### Sicherheitsmitteilung

SM 060401

## SERVICE BULLETIN #2

**Date** : 18<sup>th</sup> April 2006  
**Subject** : Damages Stated on the Plastic Loop Protection Heads of the Cutter  
**Status** : Replacement of damaged cutters and loops  
**Identification** : Any reserve parachute of which the cutter is located above the pilot chute and which has been closed by mechanical means to increase traction force or closed with a temporary pin directly placed on the cutter.

#1

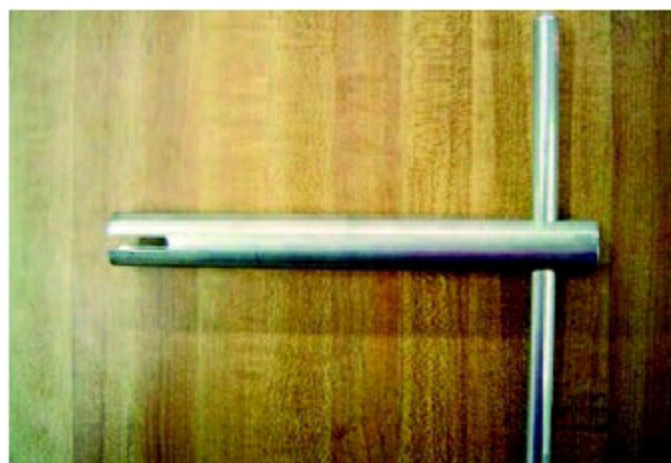
We would like to remind you that it is not allowed to use inadequate mechanical tools (force reduction systems) to close the reserve parachute. Those mechanical systems could implement a too important traction effort (above 10 daN maximum according to the TSO norms) to release the pin of the reserve parachute (see pictures #1, 2& 3 of Russian + South American + European Tools).

A particular attention is requested to look carefully that the small plastic loop protection heads of the cutter(s) are not damaged during the repack of the reserve. If any degradation sign is detected on the plastic loop protectors, it is imperative to replace the cutter unit and the loop to avoid any reserve loop deterioration.
